MONTEBELLO ESTATES JSP 15-76

Public hearing at the request of Mirage Development for Planning Commission's approval of Preliminary Site Plan, Woodlands Permit, Wetlands Permit and Stormwater Management Plan. The subject property is currently zoned R-3, One-Family Residential and is located in Section 27, west of Novi Road and north of Nine Mile Road. The applicant is proposing a 32 unit single-family detached residential development on a 26.94 acre property.

Approval/Postpone/Denial of the Preliminary Site Plan, Wetland Permit, Woodland Permit, and Stormwater Management Plan.

WETLAND PLAN

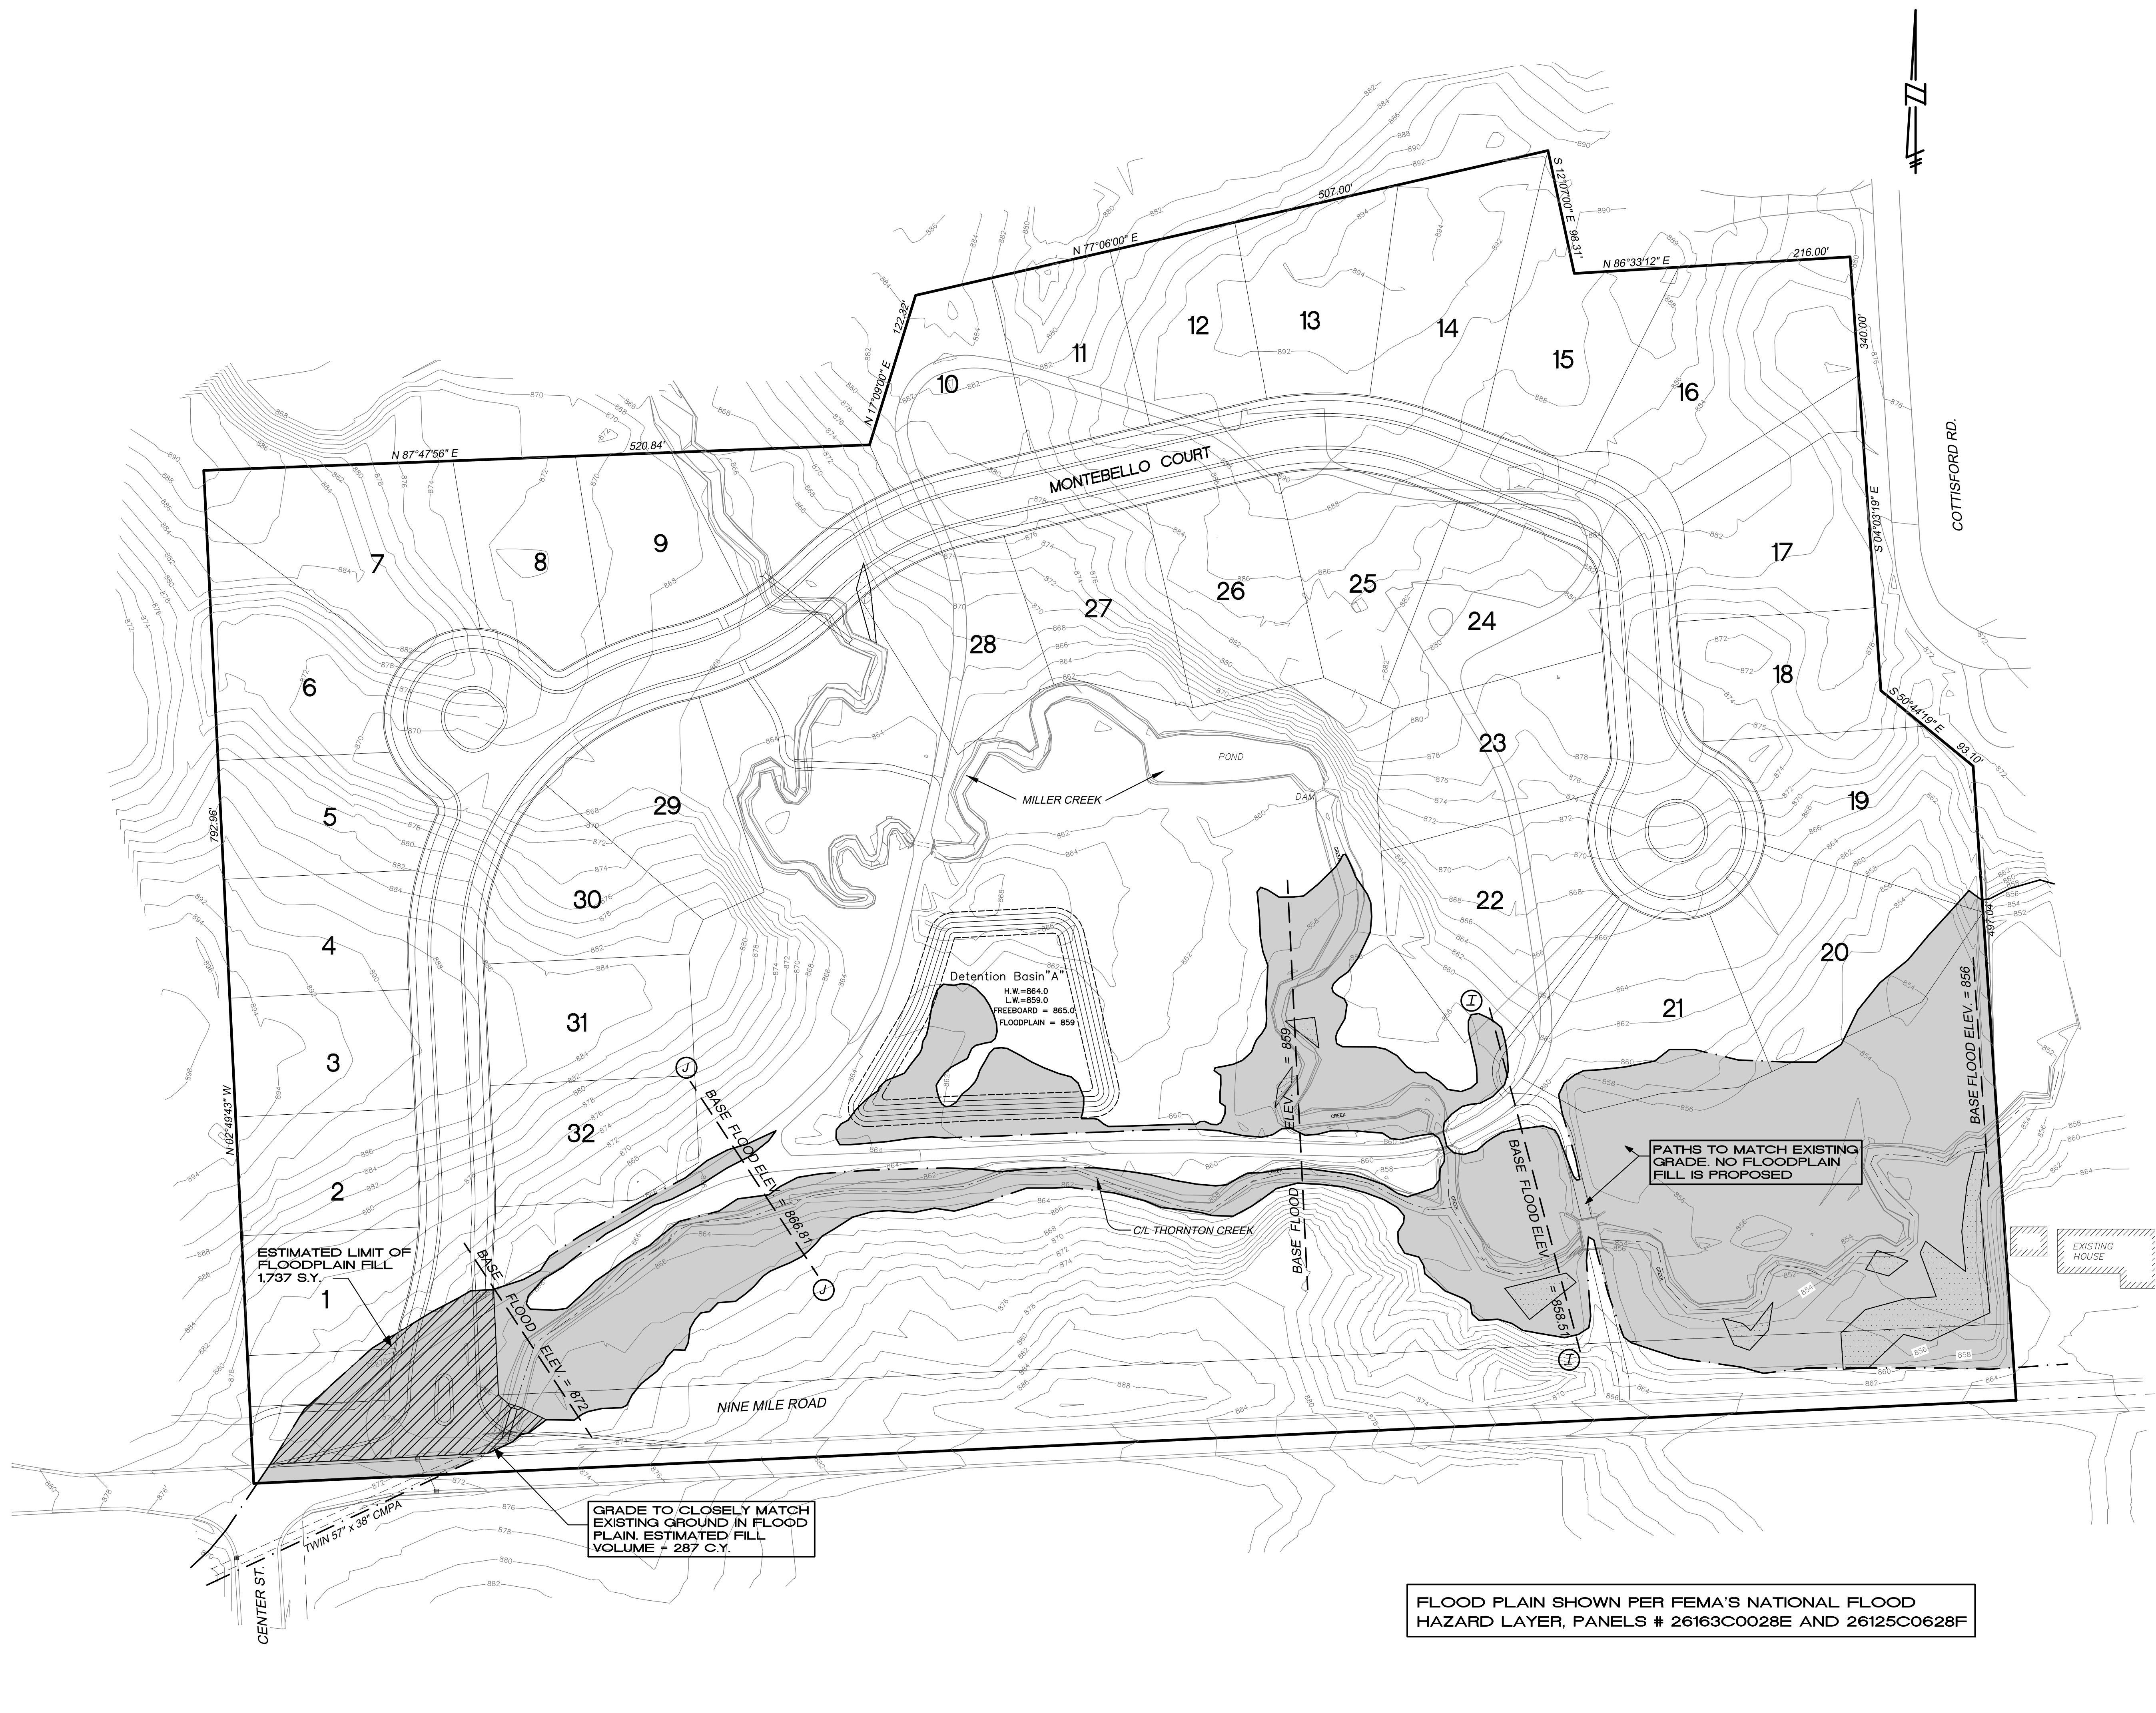
The *Wetland Plan* (Sheet 4) indicates the areas of existing on-site wetlands. As noted, these wetland areas were delineated by King & MacGregor Environmental, Inc. The wetlands were delineated by

Currently, the Plan indicates impacts to one (1) of the seven (7) on-site wetlands (i.e., Wetland G, see Figure 2). The Plan proposes to fill Wetland G (0.01-acre), located in the northern section of the site, for the purpose of constructing a section of Montebello Court as well as Lot 28. The current Plan also proposes to enclose approximately 95 lineal feet of Miller Creek via a proposed 85 lineal foot culvert for the purpose of constructing a road crossing (i.e., Montebello Court) of Miller Creek. It should be noted that the currently-proposed enclosure is an improvement over the last plan submittal. The previous plan proposed the relocation of approximately 230 lineal feet of Miller Creek via a proposed 85 lineal foot culvert for the purpose of constructing a section of Montebello Court as well as Lot 29. The old plan involved the abandonment/filling of a greater length of Miller Creek, apparently in order to include an additional buildable lot (i.e., previously-proposed Lot 29).

The following table summarizes the existing wetlands and the proposed wetland impacts as listed on the *Wetland Plan* (Sheet 4):

L-1

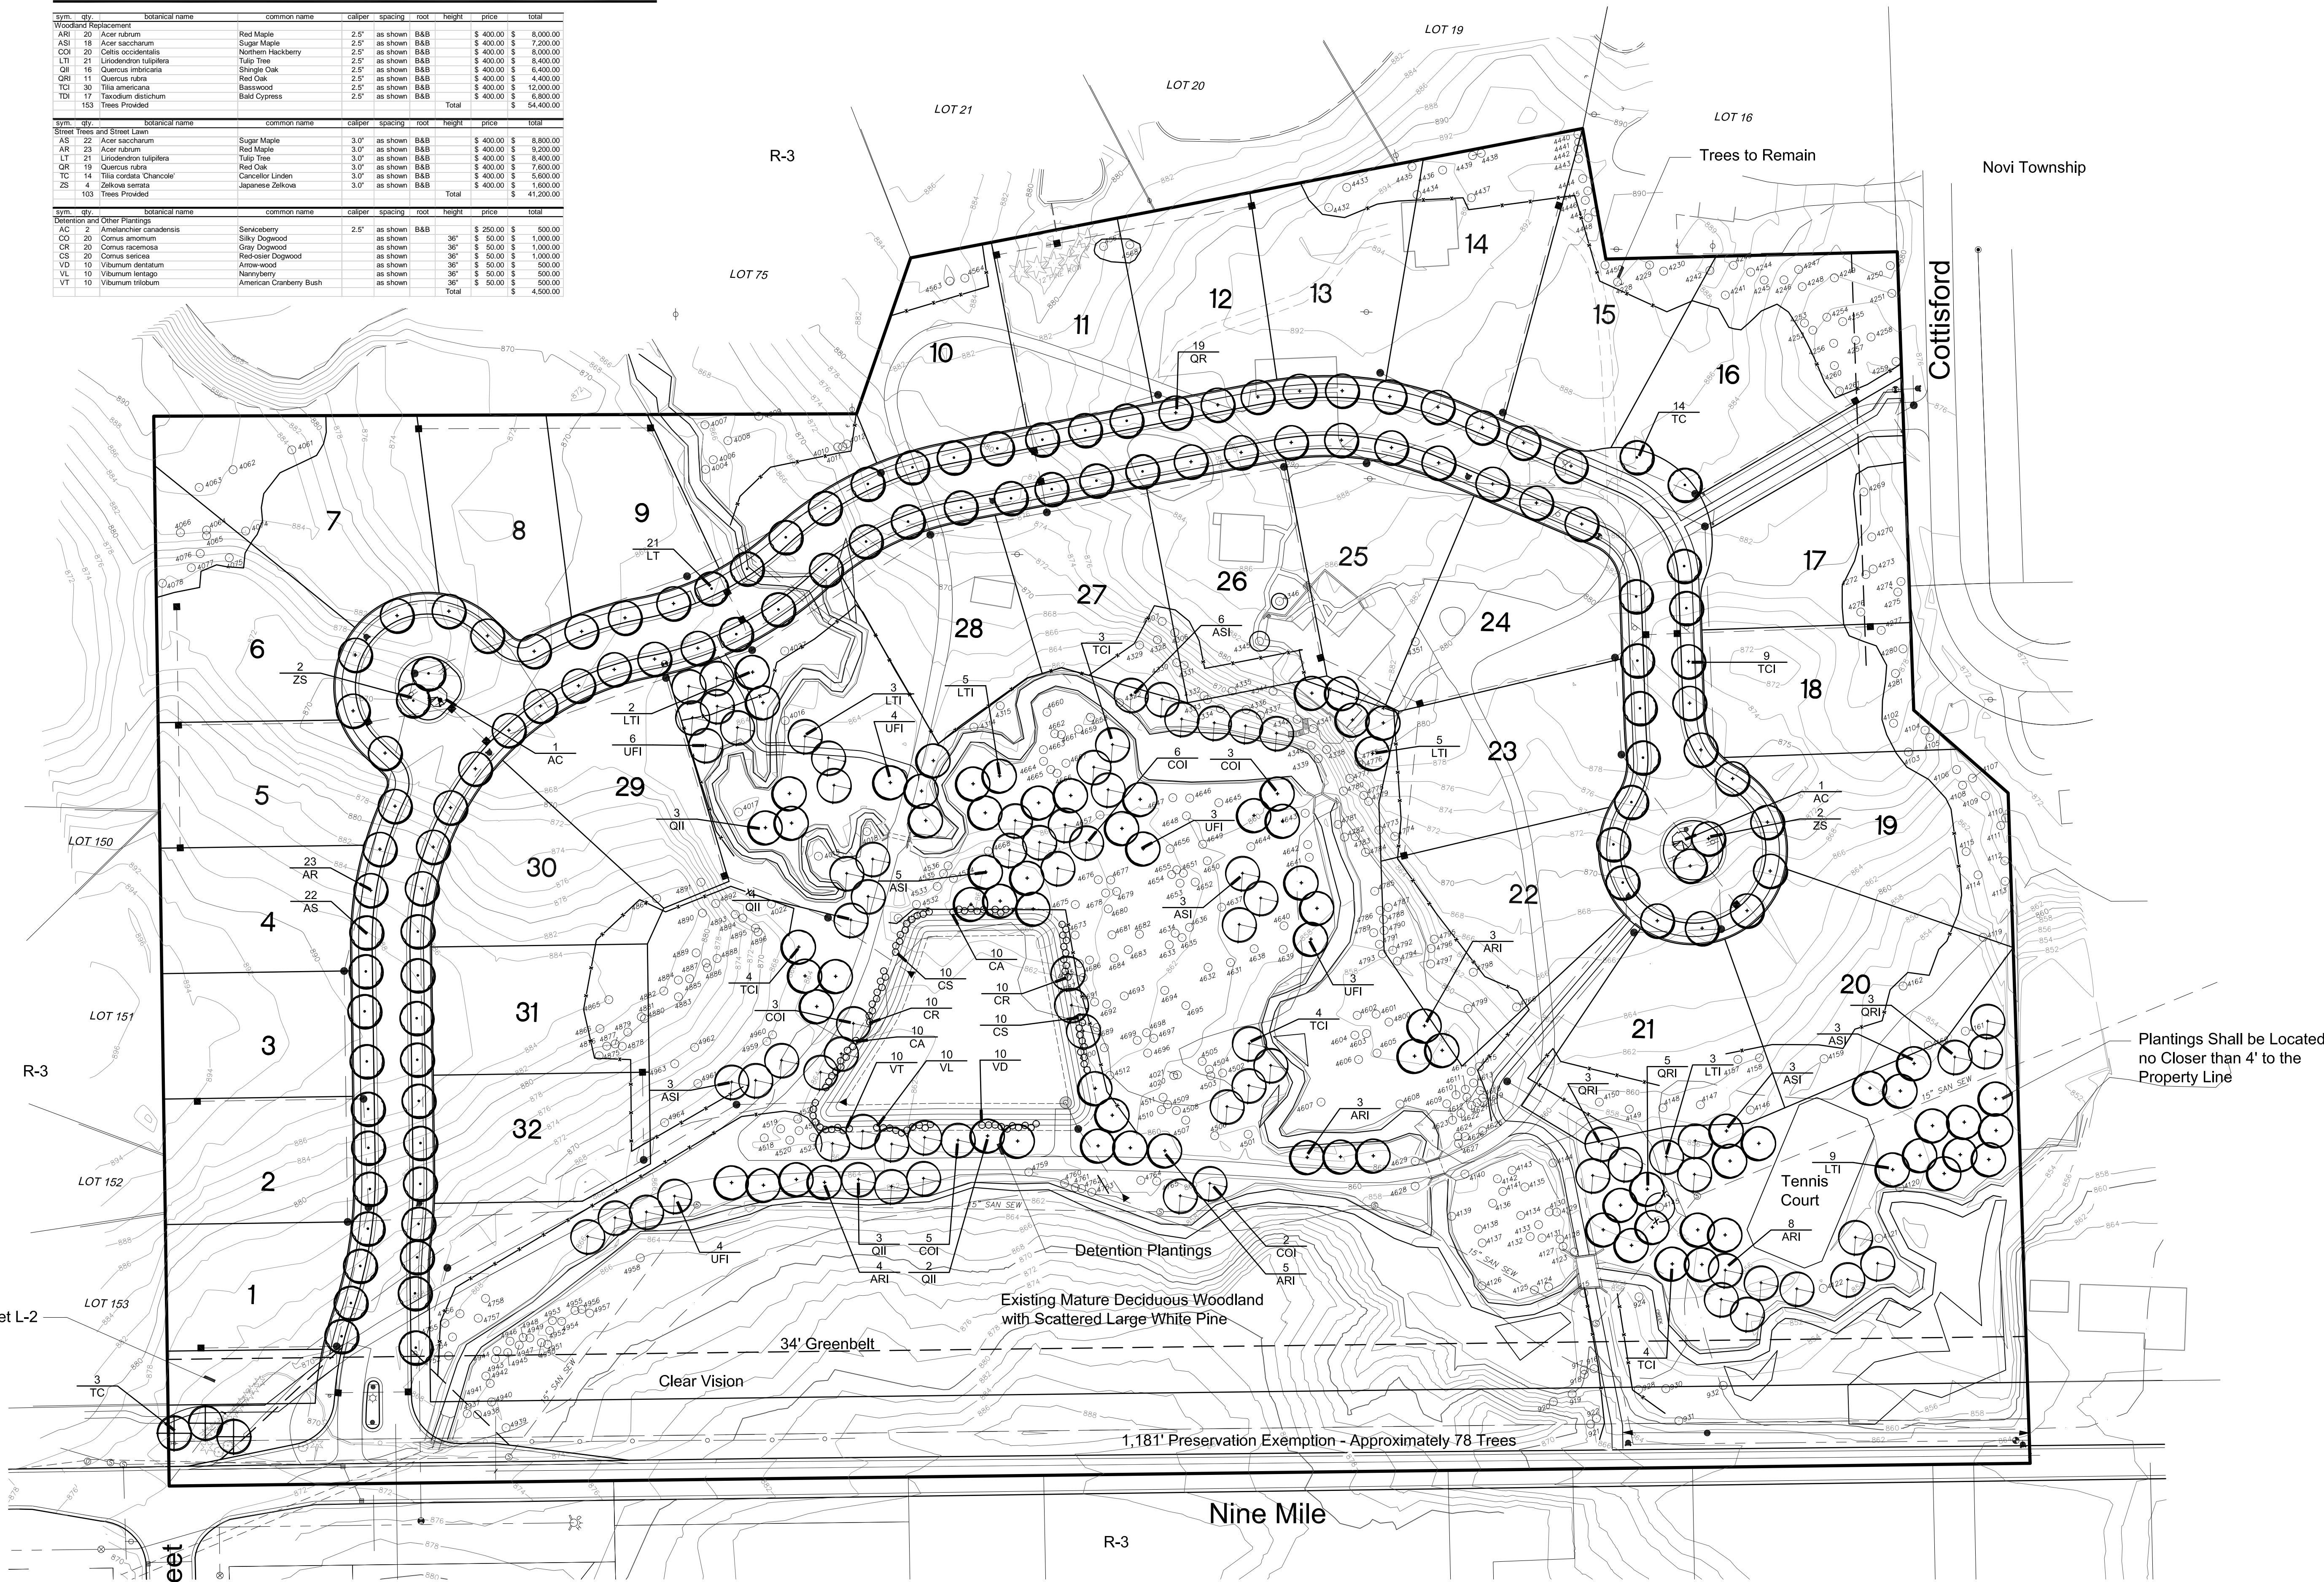
The landscape plans (Sheet L-1) appears to show a total of 153 Woodland Replacement Trees (this is only approximately 14% of the total Woodland Replacement Trees that are required). This is ten (10) more Woodland

3. The landscape plans (Sheet L-1) appears to show a total of 143 total Woodland Replacement Trees (two and one-half (2 ½) inches caliper) and count at a 1-to-1 replacement ratio. The Plan currently notes that 868 credits will be paid to the City of Novi Tree Fund. It should be noted that the applicant should provide Woodland Replacement Tree species consistent with the Woodland Tree Replacement Chart (attached). The *Chancellor linden* and the *Frontier elm* being proposed on the Landscape Plan are not acceptable Woodland Replacement trees. Please review the *Woodland Tree Replacement Chart* (attached) and revise the Plan as necessary.
